Re: Hudson Logistics Center - Conditional Use Permit  
Application Supplemental Filing

RE: Hudson Logistics Center - Conditional Use Permit Application  
Supplemental Filing

FIGURE 2

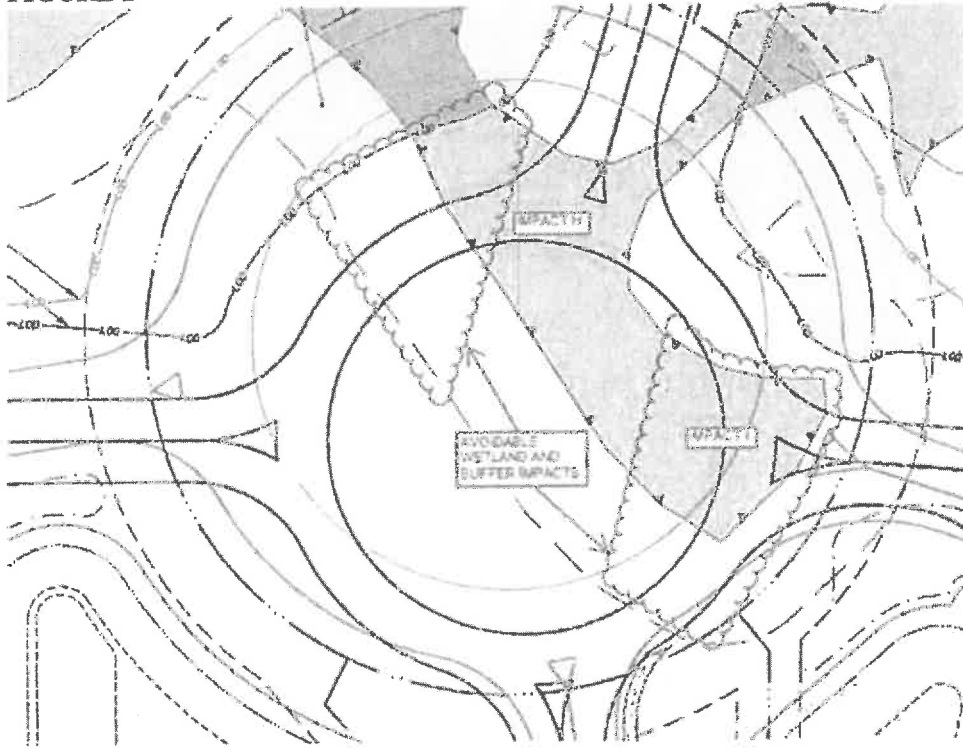
*As currently designed, the access road, Green Meadow Drive, or more specifically the traffic circle, does not avoid and minimize wetland impacts. Below is a discussion of why the current design cannot meet the definition of practicable and thus the avoidance and minimization standard cited above in Env-Wt 313.03. Refer to Figure 2 below. The red clouds identify wetland and buffer zone areas which could easily be avoided if the cul-de-sac were extended a distance that is sufficient to allow the traffic circle to be built outside of wetland jurisdiction. I estimate that distance to be approximately 150 feet. The area between the two red clouds will be impacted regardless of whether the access road is extended.*

**RESPONSE:** See GES Letter, Conditional Use Permit Narrative, cul-de-sac configuration sketches and above analysis.
